**Re: Location and Volume of Existing Waste
Upland Landfill
7295 Gold River Highway, Campbell River, British Columbia**

**LOCATION OF EXISTING WASTE
EXISTING CONDITIONS**

Re: Application for an Operational Certificate under the Environmental Management Act on behalf of Upland Excavating Ltd. (Upland)

FIGURE 1

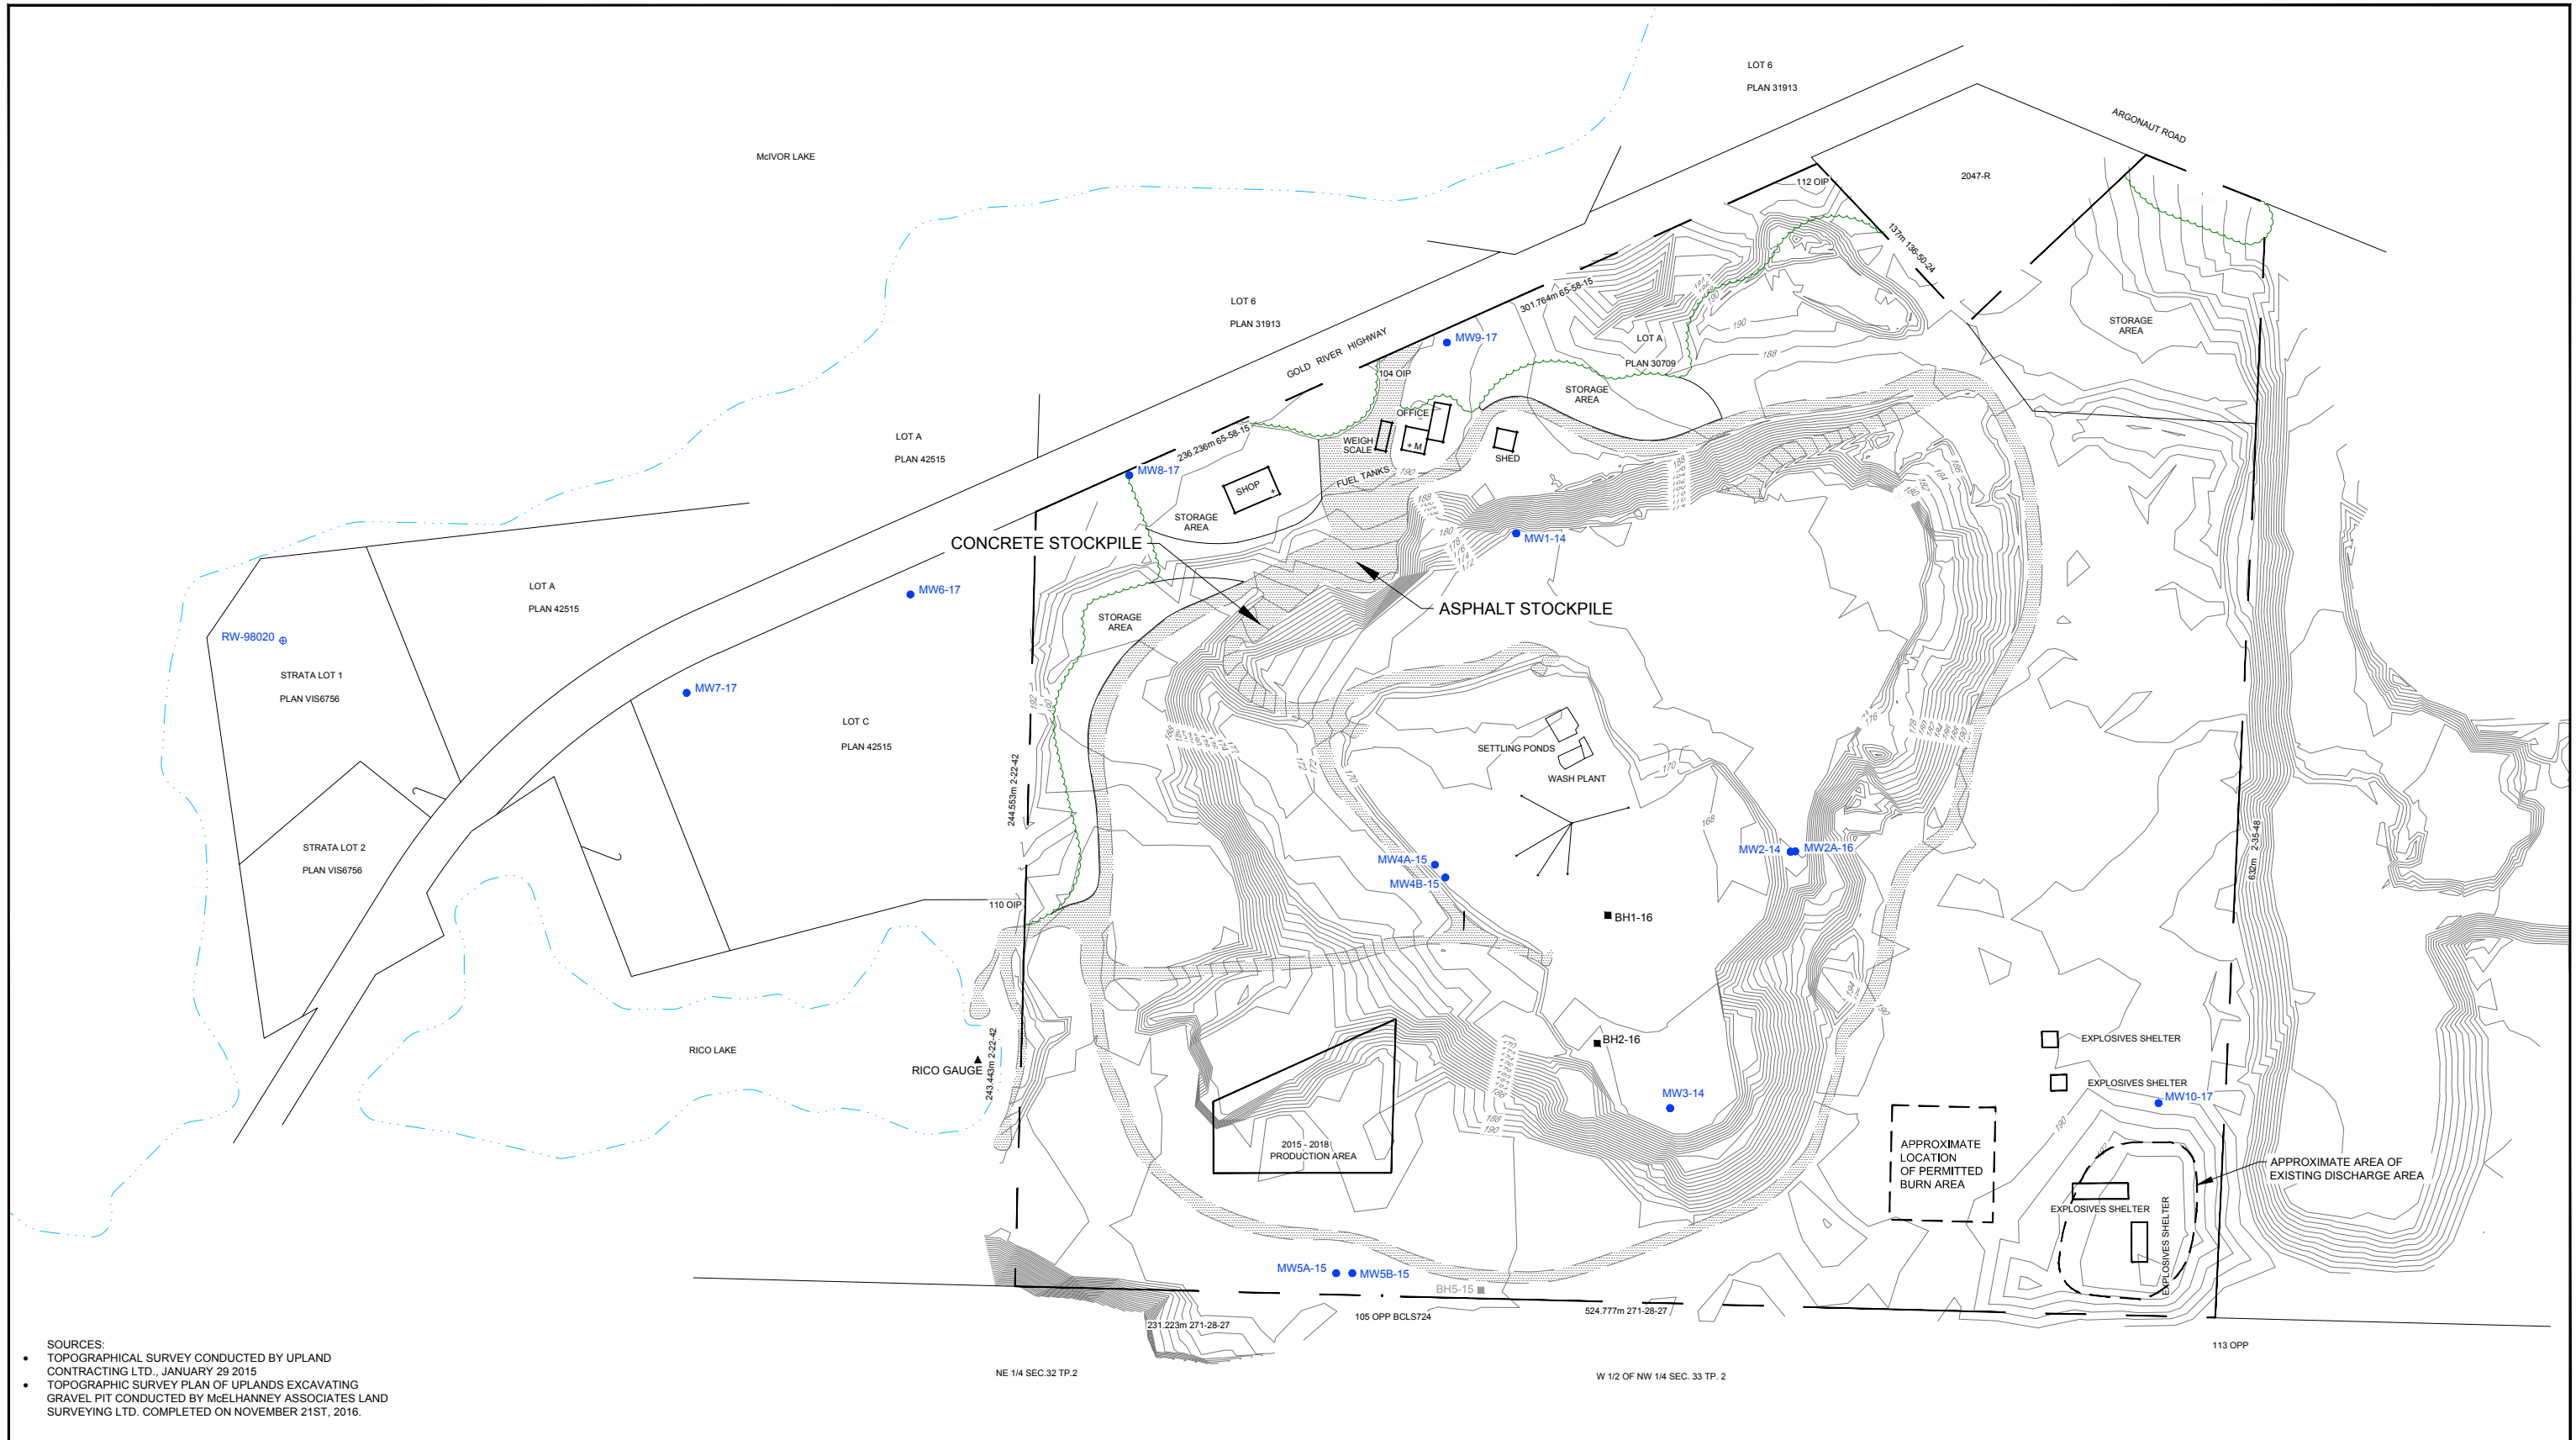
6. The existing permit authorizes landfilling. Please provide the location(s), volume(s), and waste types of any on-site landfill(s), and confirmation that that all on-site waste will be relocated into the lined landfill.

The waste discharge area is located in the southeast portion of the Upland Property, adjacent to the burn area, as shown on Figure 1. The estimated area of the waste discharge area is approximately 7,000 square meters. The waste layer is estimated to have a thickness of up to approximately 5 meters. The estimate volume of waste is approximately 35,000 cubic metres, broken down as follows:

- Land clearing waste – approximately 25,000 cubic metres
- Residue of combustion – approximately 10,000 cubic metres

Upland undertakes waste diversion by segregating reusable materials for recycling and reuse. Concrete and asphalt are the two of the principal materials segregated for re-use, such as an aggregate alternative or admixture. The location of the stockpiles of re-covered concrete and asphalt are shown on Figure 1.

The existing 35,000 cubic meters of waste will be relocated to the lined Landfill once approved and constructed.

The segregated re-covered material will not be relocated to the lined Landfill.
